HISTORIC AND DESIGN REVIEW COMMISSION June 19, 2019

HDRC CASE NO: 2019-335

COMMON NAME: ROW near 602 N Alamo ADDRESS: 602 N ALAMO ST

TYPE OF WORK: Installation of a new pole for network node equipment

view from 6th St looking northeast at site

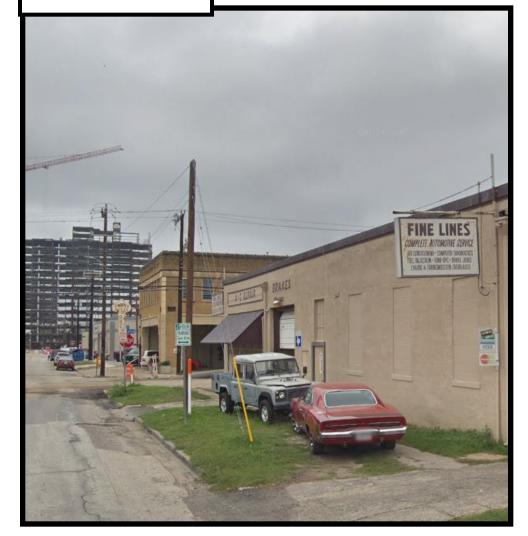
- i. DESIGN The applicant has proposed to install a wood pole with a meter socket (box), service disconnect (box) and linear conduit up to six feet (6') and three (3) au/rap units (grey cabinets) that are 11.4 inch wide, 14.6 inch tall, and extend no more than one feet (1') from the wood pole. The applicant referenced existing wood utility poles in selecting the pole type in this location. Per the Design Manual 3.B.: *The Historic Preservation Officer may require concealment of the support pole in the form of aesthetically appropriate street lamps, site elements, district signage, or other stealth methods. The color of any new support pole or concealment solution shall be determined by the Historic Preservation Officer based on site specific conditions.* Staff finds that no effort has been made to conceal or relate the proposed new pole to the existing context or site elements at N Mesquite except the use of a wood pole and matching equipment color.

- i. COLLOCATION Documented efforts to explore a nearby collocation have not been submitted.
- ii. LOCATION The proposed pole is not located at a commercial intersection or in-between buildings facades.
- iii. SEPARATION The proposed pole is not separated from existing poles by more than 250 feet.
- iv. DIAMETER The proposed pole is not less than 8 inches at its widest portion.
- v. DESIGN Matching wood material to existing poles does not constitute a stealth aesthetic.
